# Access Compliance Report

## Public Rights-of-Way

| Intersection ID: 6218                   | Main Street: BEAM_LAKE_DR | Cross Street: PEACHWOOD_DR              | Location: SW           |
| ADA ID: F82CEBAFC3E7                    | Ramp Type: PerpDiag       | Initial Pass/Fail: Fail                 | Overall Compliance: No |

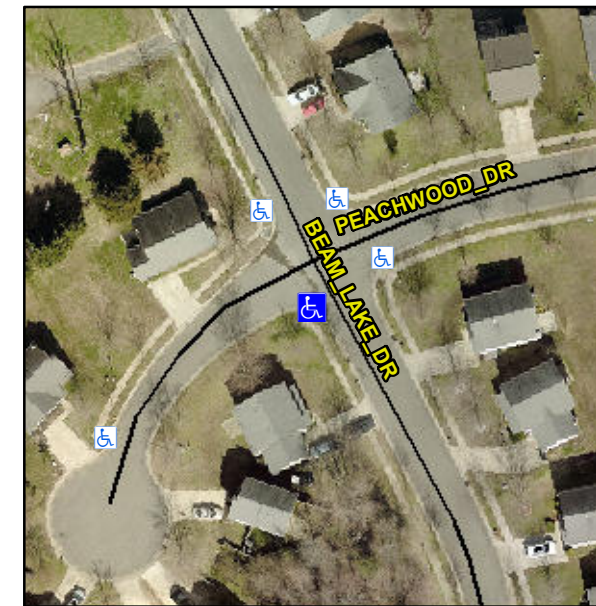
**Not Found, R304.5.1, R304.5.3**

| Compliance | Description           | Data  | Compliance | Description                 | Data  |
|------------|-----------------------|-------|------------|-----------------------------|-------|
| N/A        | Ramp Length (in)      | 47.0  | Yes        | Ramp Slope (%)              | 7.4   |
| No         | Ramp Width (in)       | 26.0  | No         | Ramp XSlope (%)             | 3.0   |

**Remove & Replace Curb Ramp With Two New Directional Ramps or Equivalent.**
